Sub Regional RTEP Committee: Western Dayton Supplemental Projects

Dayton Transmission Zone: Supplemental Germantown 69kV Capacitor

s0330

Install 12.6 MVAR Capacitor bank at Germantown 69kV bus

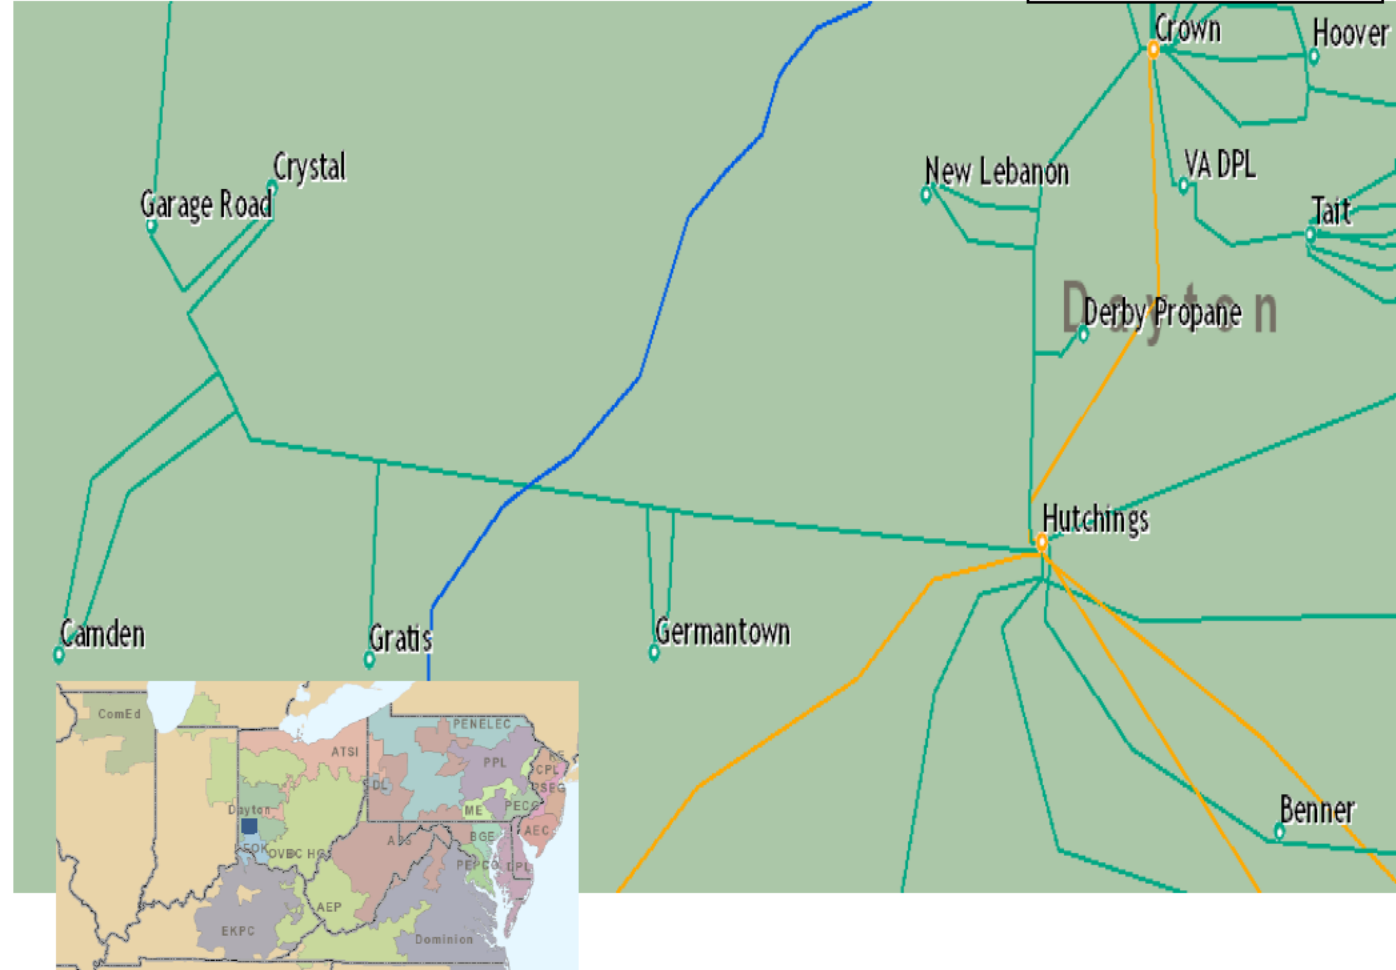
- After discussions with Dayton transmission operations and engineering teams, the Germantown Substation is not the best location for this capacitor bank and it is not needed for operational reliability. Gratis Substation would be a more centrally located substation on the 6602 circuit. In the future, if a need arises on the 6602 circuit, a capacitor bank combined with circuit breakers would be better integrated at Gratis Substation.

- PJM has completed the "Do No Harm" study and there were no reliability issues identified by removing the capacitor bank.
